MENTOR LIGHTING REPLACEMENT Addendum #1 7-28-2025

E-101 – PARTIAL HEATED STORAGE AND SERVICE AREA LIGHTING PLAN

E-601 – LIGHTING FIXTURE SCHEDULES AND NOTES

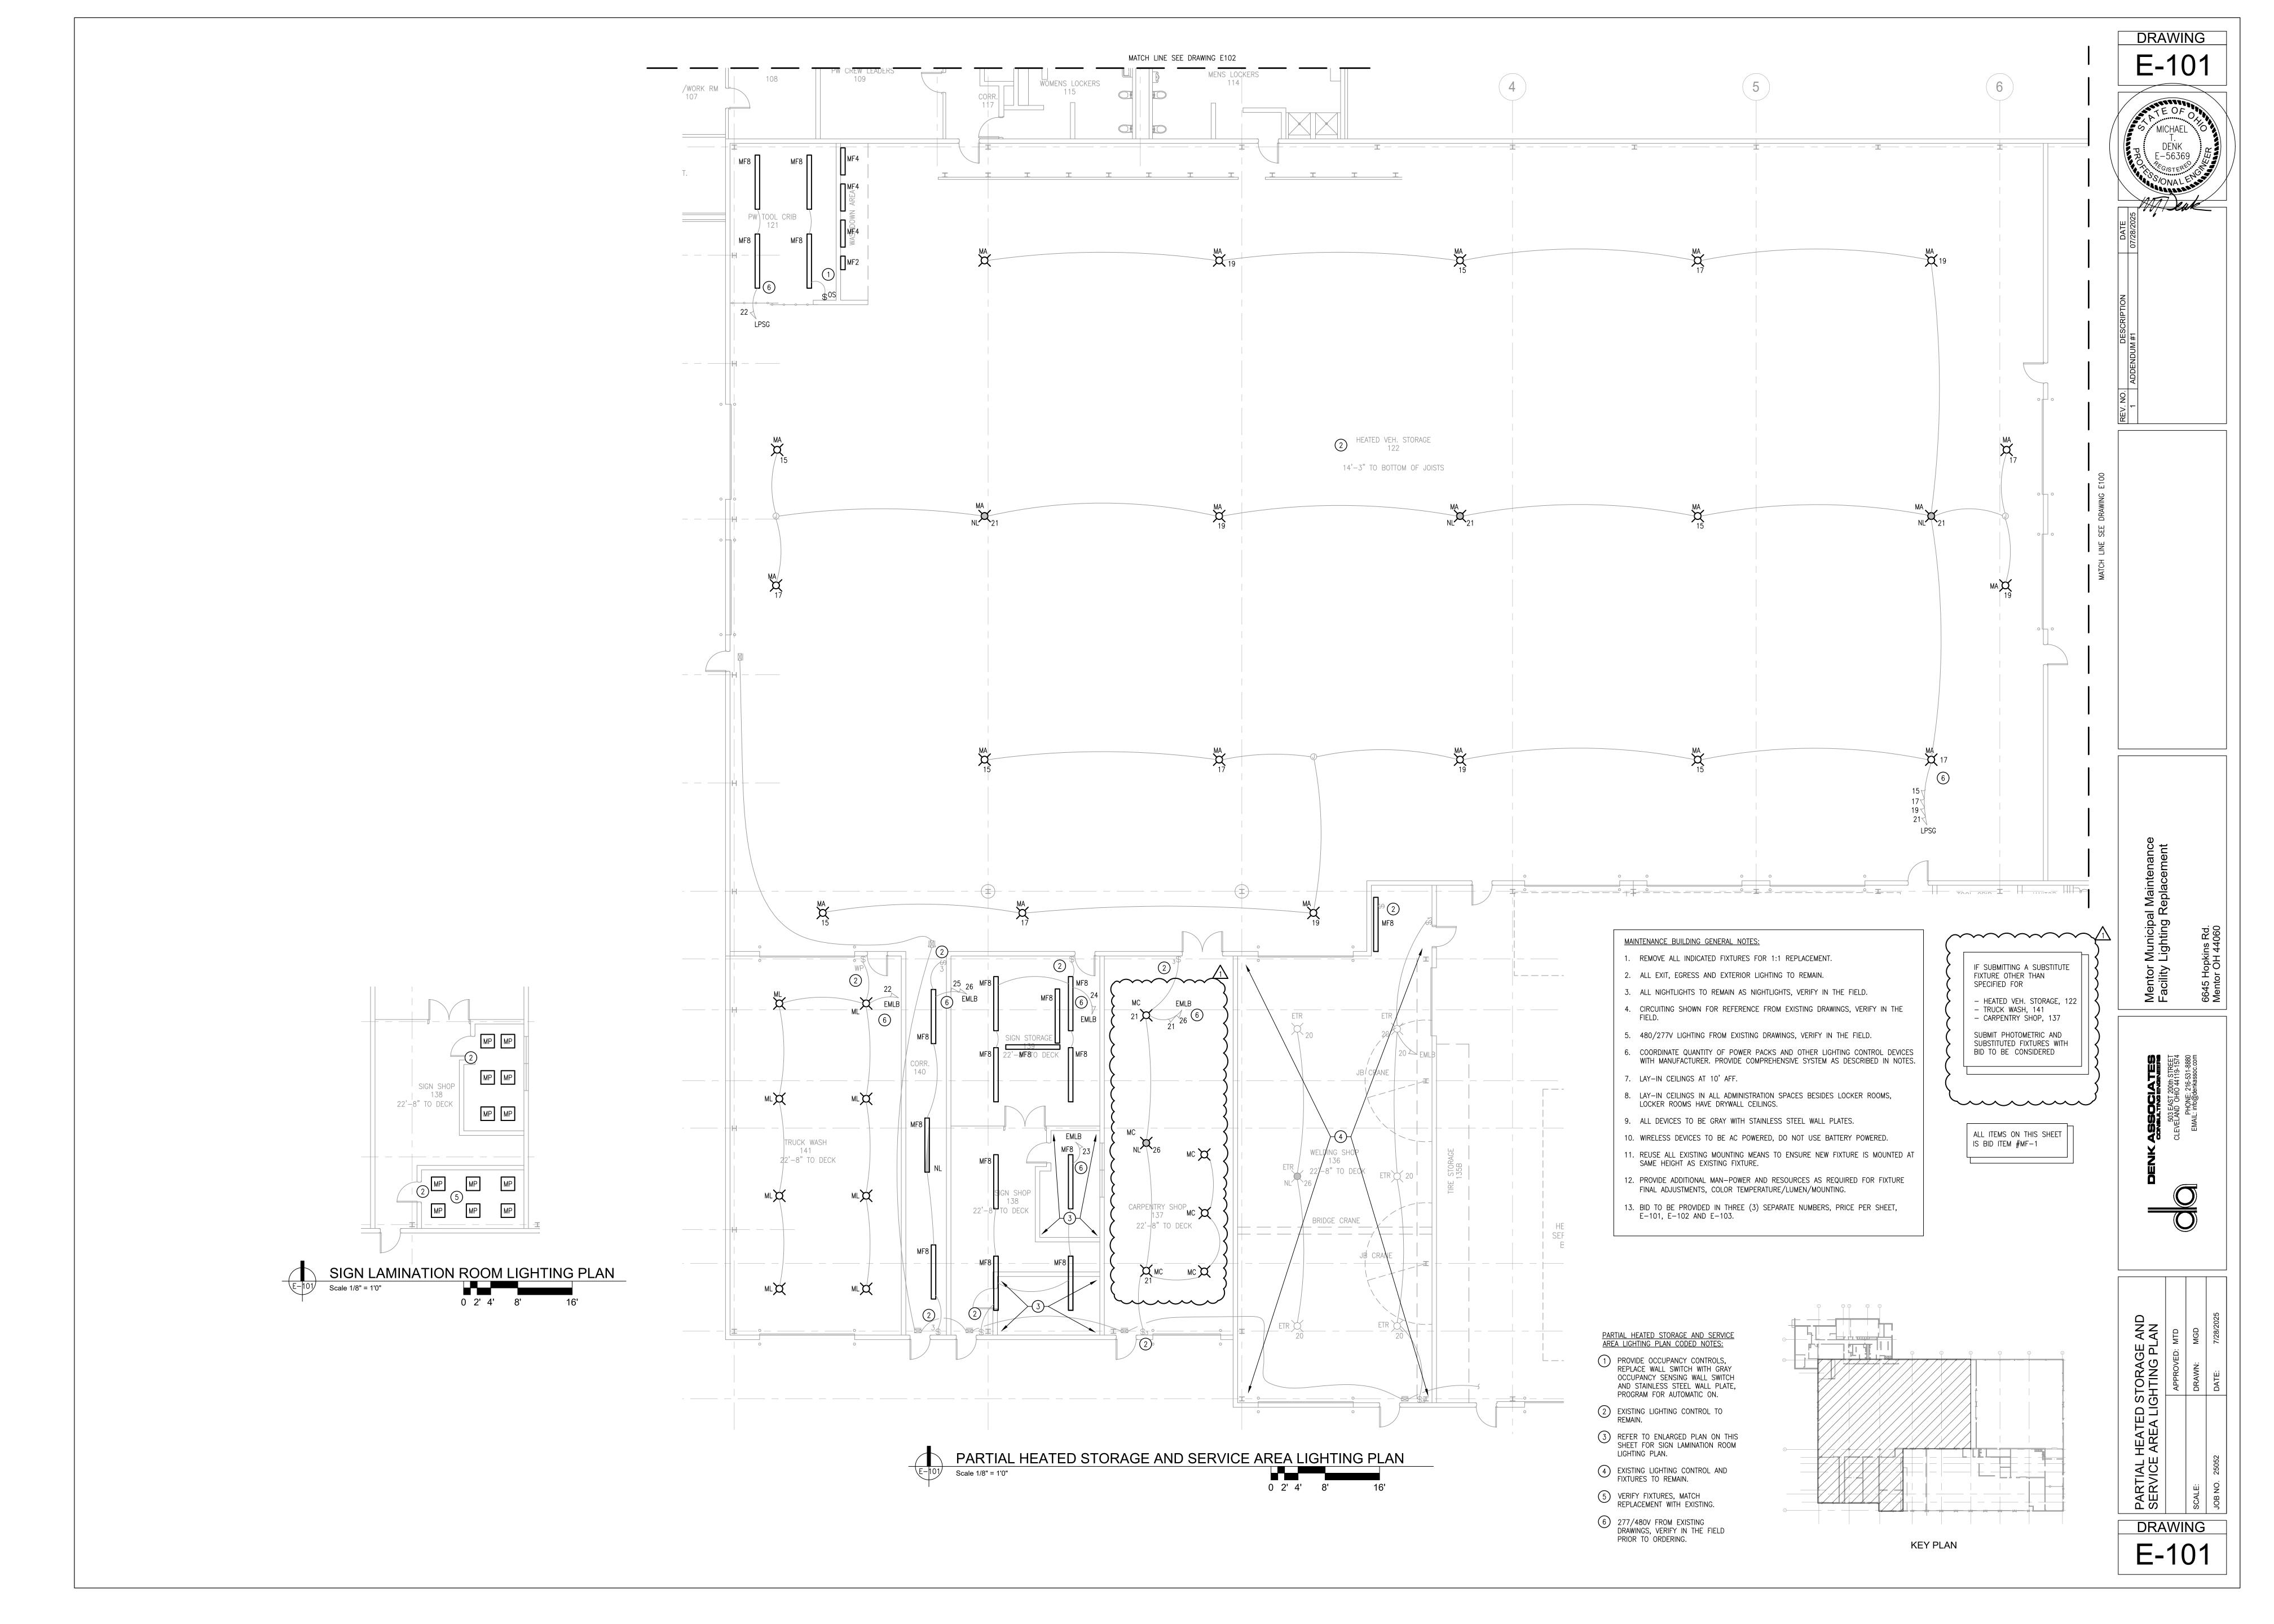
General note added MAINTENANCE FACILITY & FIRE STATION GENERAL NOTES:

- 1. CONTRACTOR SHALL WALK EACH SPACE TO CONFIRM EXISTING LIGHTING LAYOUT AND FIXTURES PRIOR TO ORDER.
- 2. CONTRACTOR SHALL ADVISE ENGINEER OF ANY DISCREPANCIES THAT ARE NOTED.
- CONTRACTOR SHALL REVIEW THE NOTED BID ITEMS AND MAKE SURE THE FIXTURES AND AREAS ARE INCLUDED PER THE BIDDING DOCUMENTS AND BIDDING ITEMS.

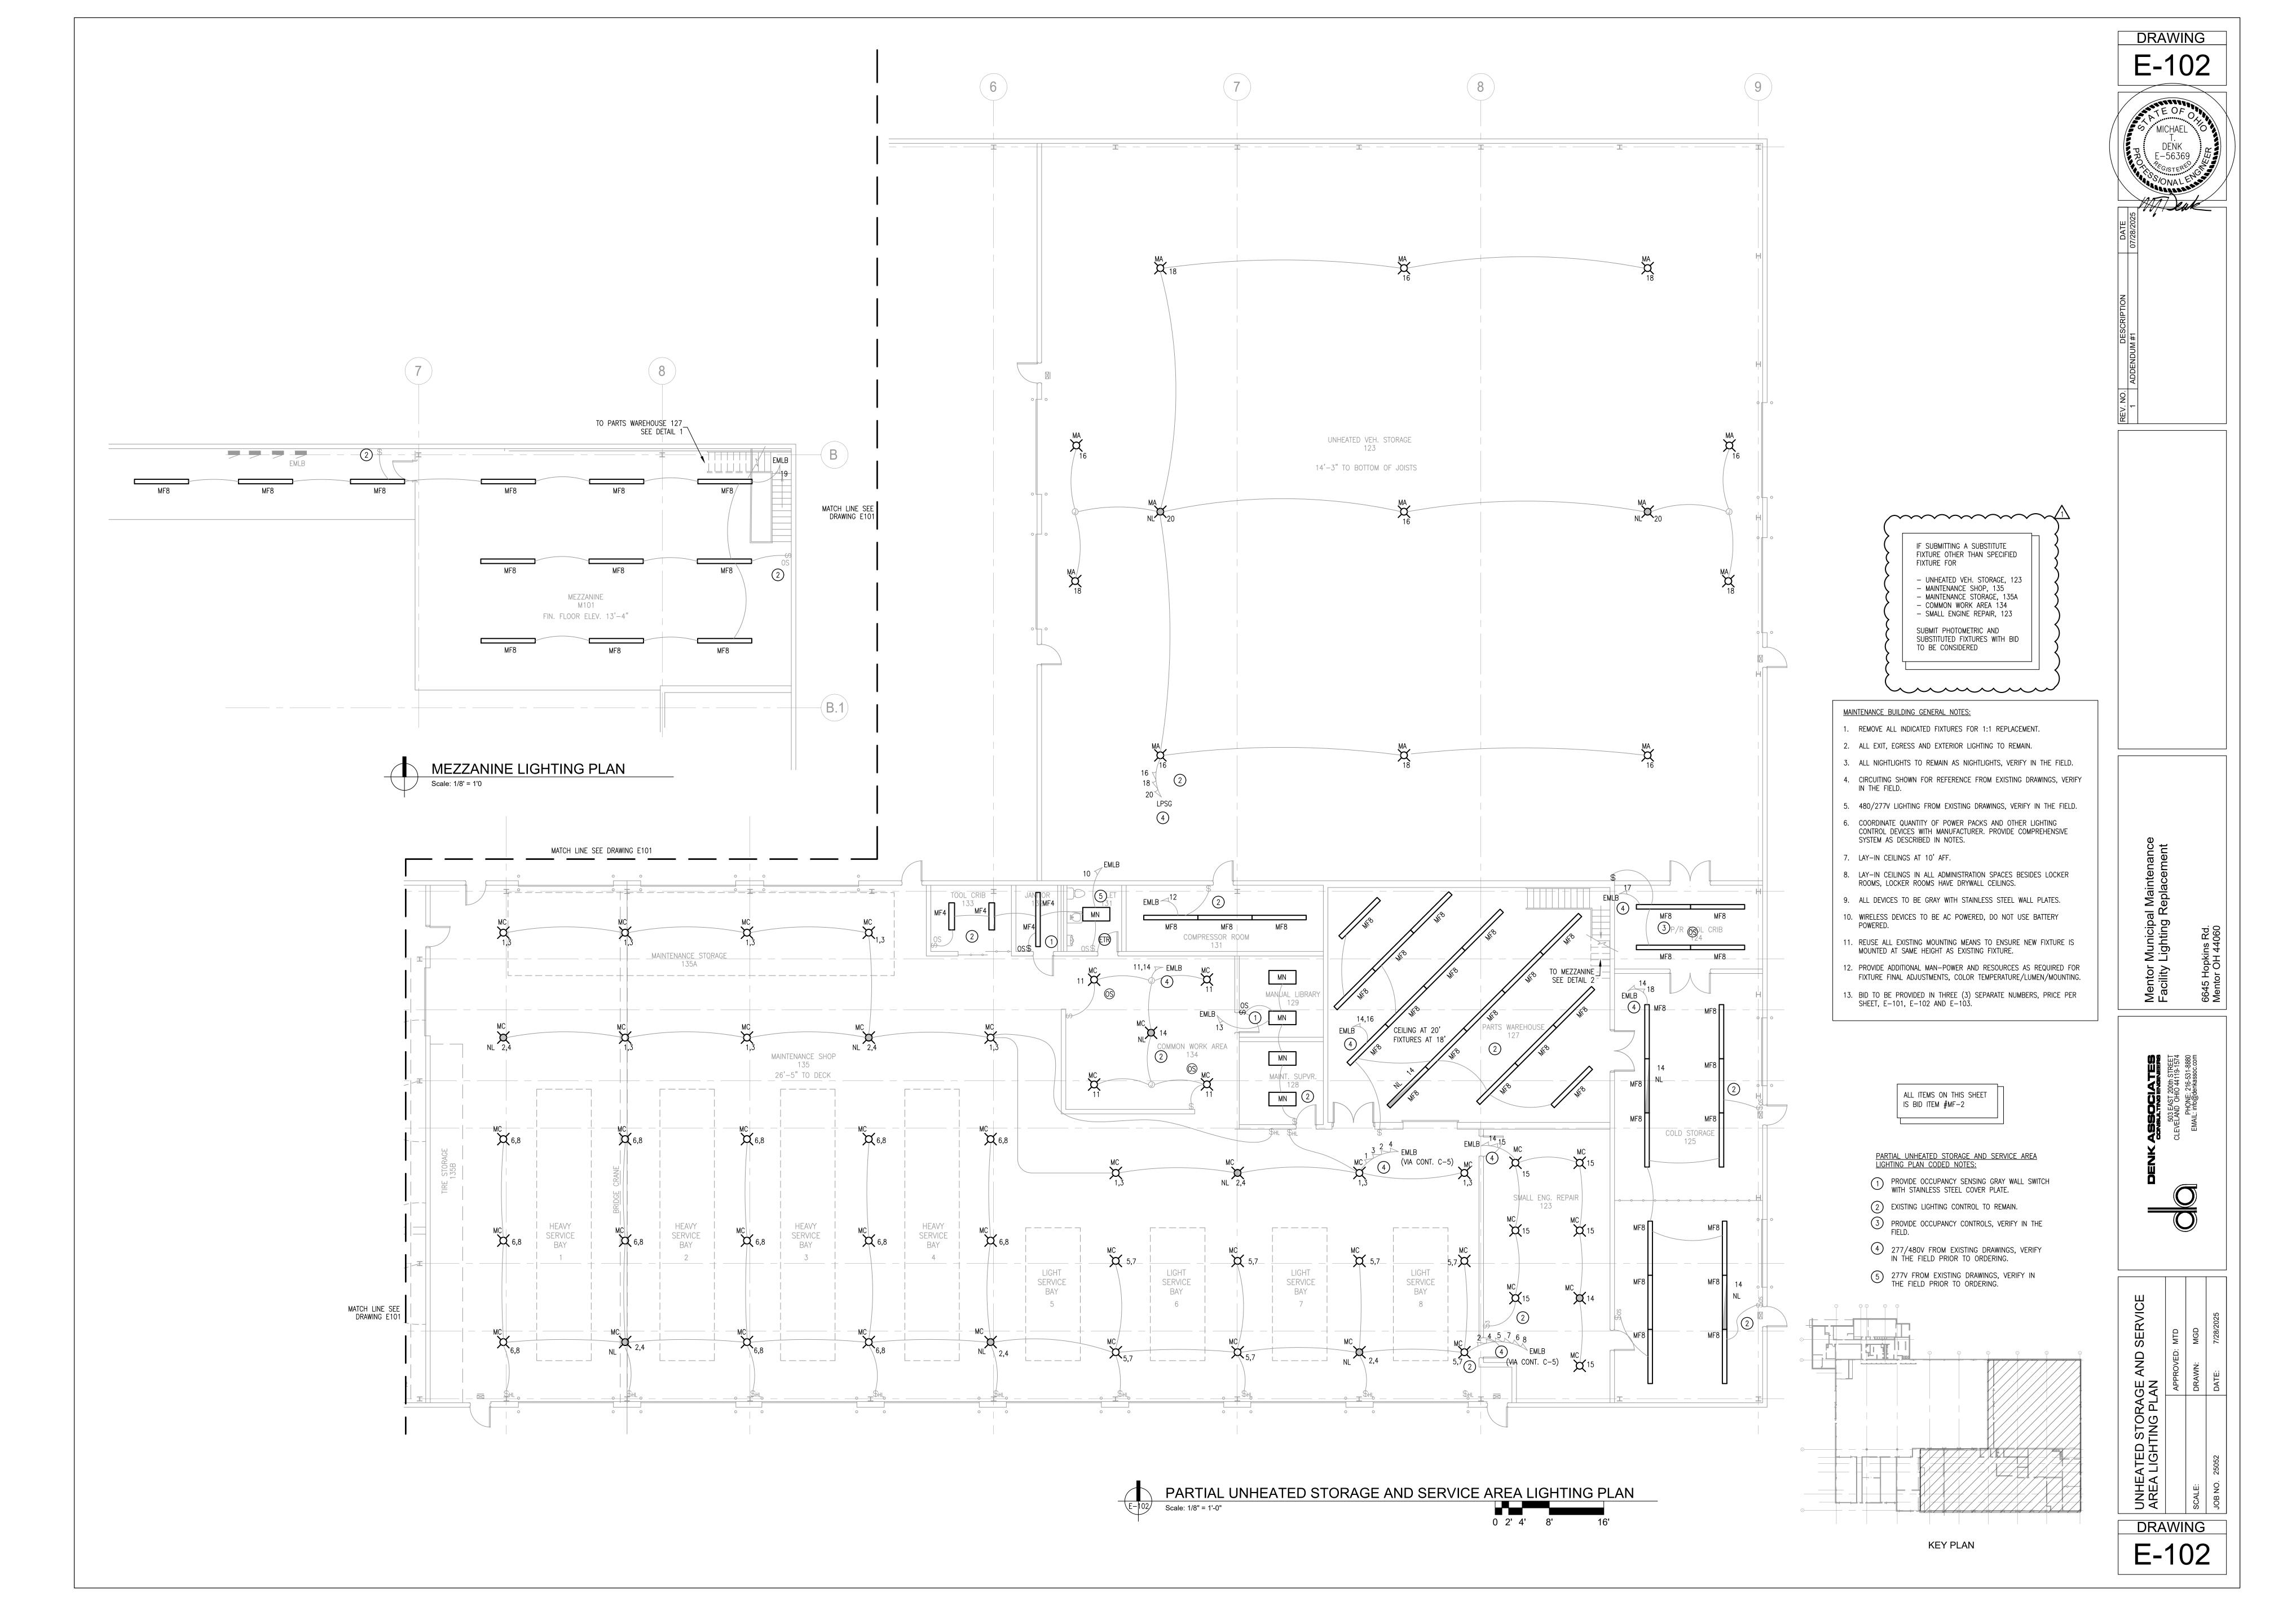
Fixture FP revised to be 11,500 LM
